STATE OF IDAHO
DEPARTMENT OF WATER RESOURCES
IN-OFFICE REVIEW/BENEFICIAL USE FIELD REPORT

A. GENERAL INFORMATIONPermit No: 77-14332

Permit 77—14332 – Field Exam Map -- Dan Nelson

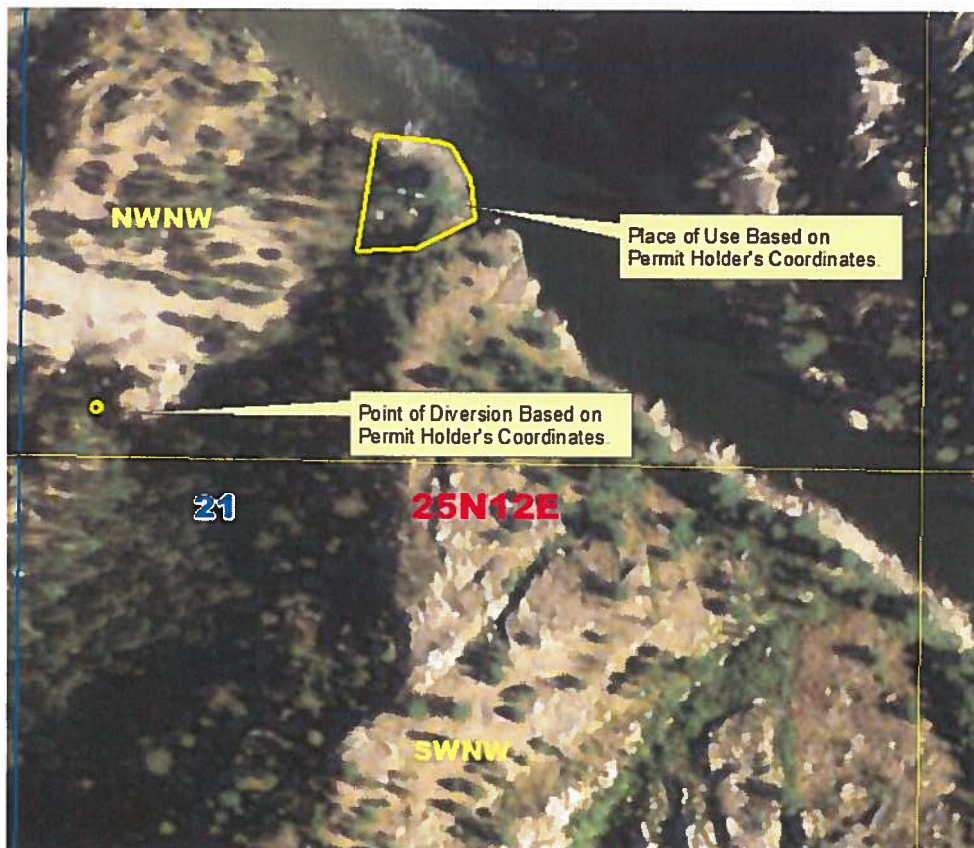
The application for permit and the permit describe the point of diversion and place of use as being in the SWNW quarter of Section 21 in Township 25 North, Range 12 East. The permit holder supplied GPS coordinates of the point of diversion and place of use. The GPS points show that the point of diversion and place of use are clearly in the NWNW quarter of Section 21 in Township 25 North, Range 12 East. I reviewed the BLM General Land Office Records, and found that a surveyed point designating the section line between Section 22 and Section 27. I have marked that surveyed point on the map below with a green dot. This survey point suggests that the place of use and point of diversion are both in the NWNW Quarter of Section 21.

After discussing this matter with staff, we agreed that we should correct the point of diversion and place of use based on the most current information available, but we shouldn't require the permit holder to pay for an amendment. The reason for not requiring an amendment is that the place of use and point of diversion haven't changed, and there is no accurate definition of the correct legal description for this area. Therefore, the legal description describing the place of use was not and still is not properly defined. The place of use description we are using to license this permit is based on the most current available data, but it could change in the future if this area is ever properly surveyed. The permit holder should not be required to pay an amendment fee if we do not have conclusive data to ensure that the legal description described in the application for permit was done in error.
